SITE DEVELOPMENT PLAN

GREENSPRINGS COMMONS

JAMES CITY COUNTY, VIRGINIA

STORMWATER RUNOFF ANALYSIS
& DETENTION BASIN DESIGN

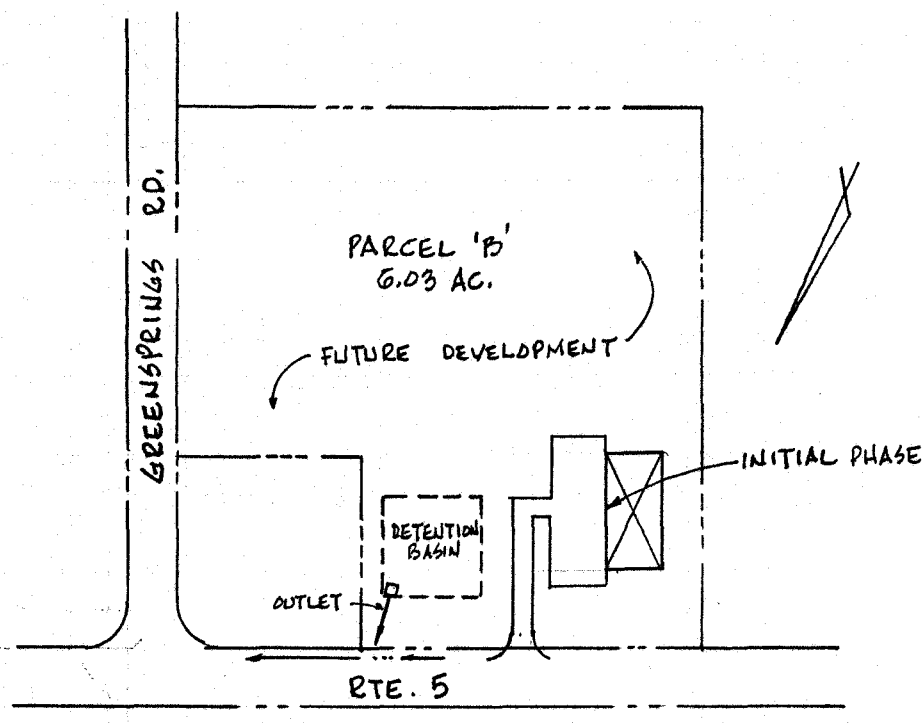
- AREA = 6.03 ACRES (TOTAL PARCEL)
- USE SOIL CLASS 'D' (SCS MAP #21)
  60% IMPERVIOUS AREA, CN = 98
  40% GREEN AREA, CN = ~~80~~ ✓
  } AVERAGE CN = ~~91~~ ok
- HYDRAULIC LENGTH = 550'
- AVG. SLOPE = 0.7%

~~74 - Good open space~~
~~70~~
T_c = 0.52

BMP POINT SYSTEM

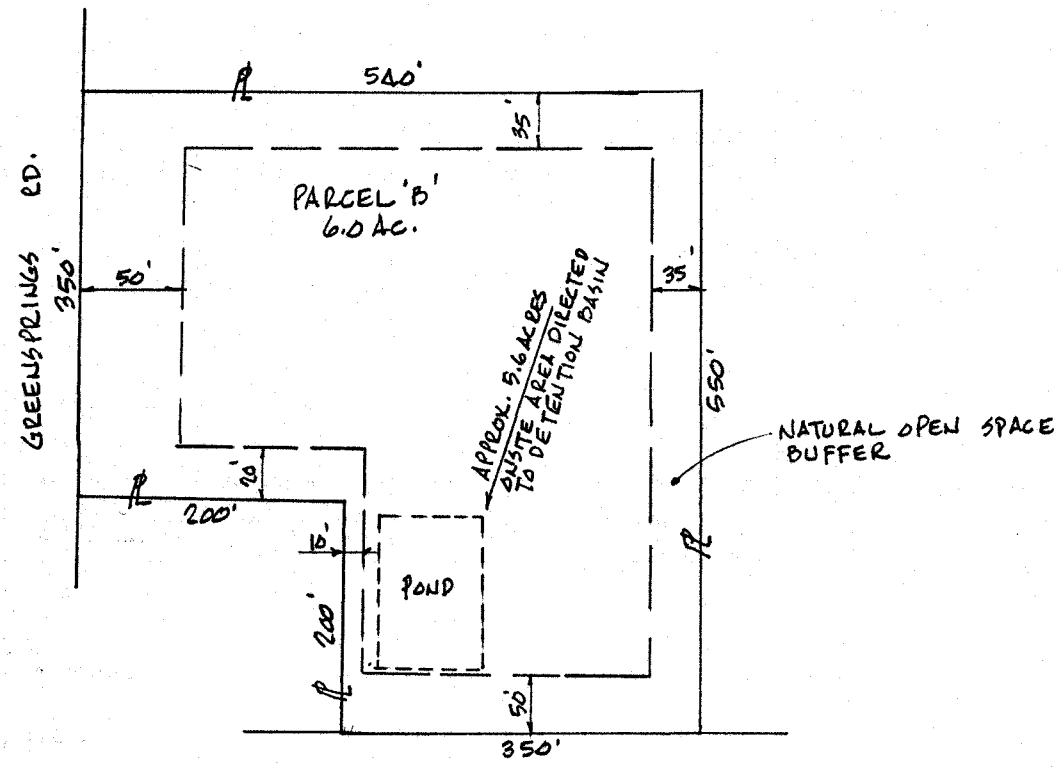
- LOWER STAGE (SHALLOW MARSH) VOLUME = 5949 CF / 43560 = 0.14 AC-FT
- NUTRIENT LOAD $[(P)(P_j)(R_v)/12](c)(A)(2.72)$
  N = [(44)(0.9)(0.59)/12](2.00)(6.0)(2.72) = 63.55 #/yr.
  P = [(44)(0.9)(0.59)/12](0.26)(6.0)(2.72) = 8.26 #/yr.
- AVERAGE ANNUAL LOADING PER WETLAND ACRE
  LOWER STAGE AREA (6" DEPTH) = 0.14 AC-FT / 0.5 FT = 0.28 AC
  N = 63.55/0.28 = 227 lbs/acre/yr.
  P = 8.26/0.28 = 30 lbs/acre/yr. → 44 lb/ac
  0.5' deep use 8303 ft²

B. NATURAL OPEN SPACE:
28% OF SITE @ 0.1 per 1% = 2.8 pts
provided on plat - 18%
